AMENDMENTS TO THE DRAWINGS:

REMARKS

Claims 1-13 are pending. The claims have not been amended. In the Office Action mailed October 5, 2005, the Examiner rejected claims 1-4 and 7-9 as anticipated by U.S. Patent No. 5,402,734 to Galpin, et al. ("Galpin"). The Examiner also rejected claims 5-6 and 10-13 as unpatentable over Galpin. Applicant hereby traverses these rejections.

Fig. 1
(Prior Art)

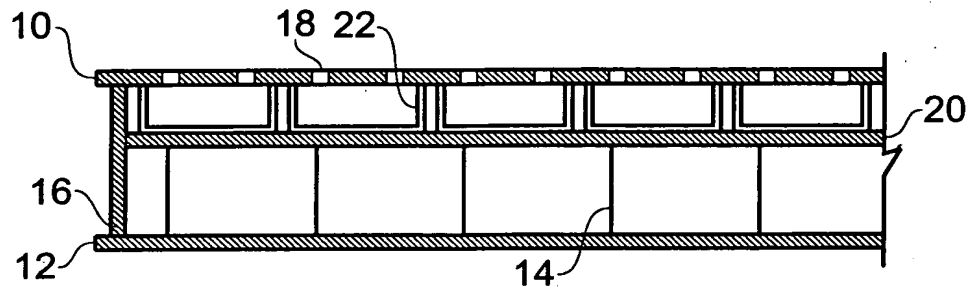
The attached sheet of drawings includes adding "Prior Art" as a legend to Figure 1.
